RT 144

PERMIT CARD _____

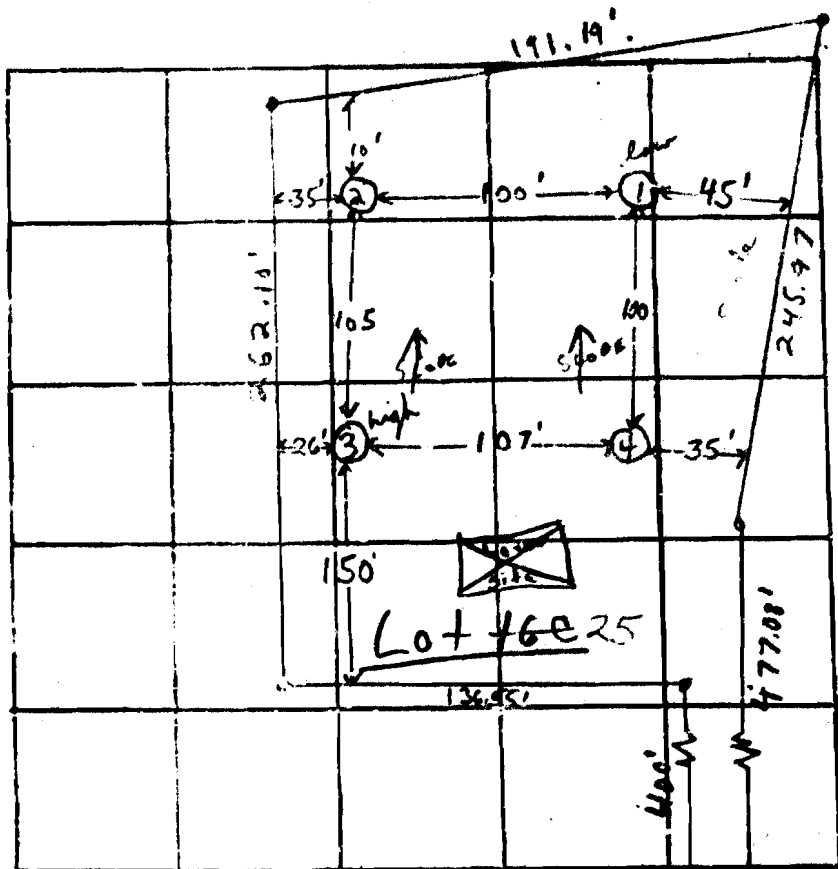
REMARKS 8/16/78 - NEED TO EXTEND TRENCH 10 FT MORE

8/16/78 - INSTALL CLEANOUTS ON SEPTIC & DW. PUT GRAVEL

TRENCH - CALL FOR INSPECTION FOR EARTH BUFFER FROM DW

to trench is only 3' - warning given (GLK)

8/18/78 FINAL OK FOR (GLK)
